Product Change Notification

1. **ECR #:** 218869
Notification #: 658

3. **Series:**
• UMPS - UMPS ASSEMBLY

4. **Part #'s Affected**
• UMPS-XX-XX.X-XX-V-X-X-XR

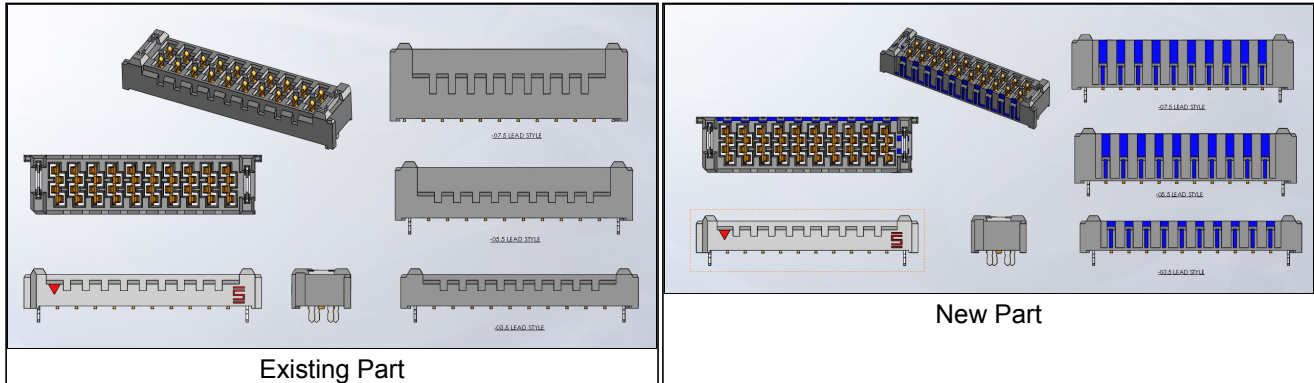
5. **Description of Change:**
Change the outer void of side rib design and add void to right Weld tab hole.

6. **Method of Identifying Change**
Visual inspection, see picture for the body changes highlighted in blue color.

7. **Reason for Change:**
Change made to improve body knit line.
